Replacing Fuel Filler or Charging Door Flap

Model	Model Year	Model Type	VIN Range	Vehicle-Specific Equipment
Panamera	2018	971	N/A	N/A

Installation Position

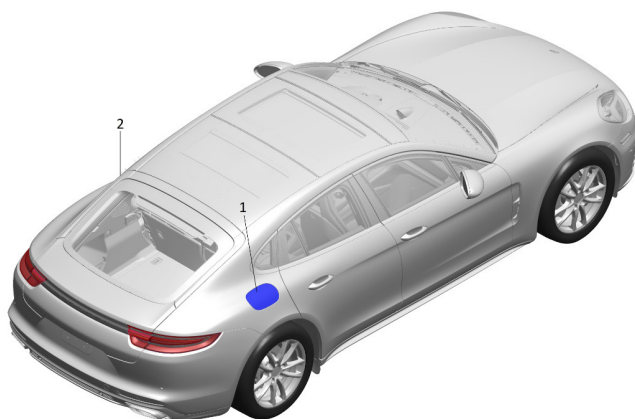
The fuel filler door flap, or the charging door flap is difficult to open or close.

The tolerance for the flap against the body is too tight.

Replace the fuel filler door flap or charging door flap. A revised part is now available at our PDC.

971.809.909.BY	Fuel Filler Door Flap	1 ea.
971.809.920 BY	Charging Door Flap	1 ea. (Panamera E-Hybrid Models only)

Preparation

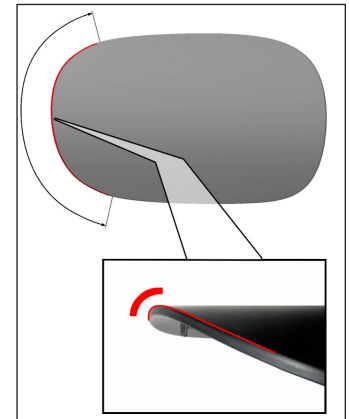
Due to the rework of the original parts by the supplier, a visible and perceptible edge may be present on the upper side of the flaps. If this is the case, smooth out the red marked edge with suitable sandpaper.

Replacing:

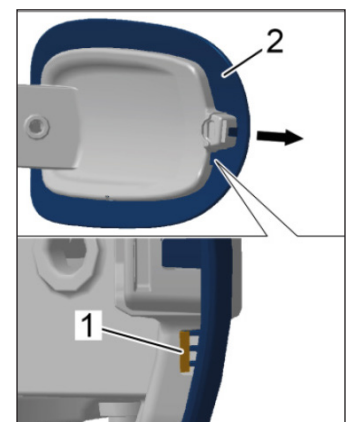
1. Replacing fuel filler door flap or charging door flap
 - 1.1 Open the fuel filler door flap or charging door flap
 - 1.2 Release catch -1- using a suitable tool, and pull off the flap -2- in the direction of the arrow
 - 1.3 Gently push the new flap in the opposite direction until it noticeably locks.
2. Check the fuel filler door flap or the charging door flap for ease of operation.
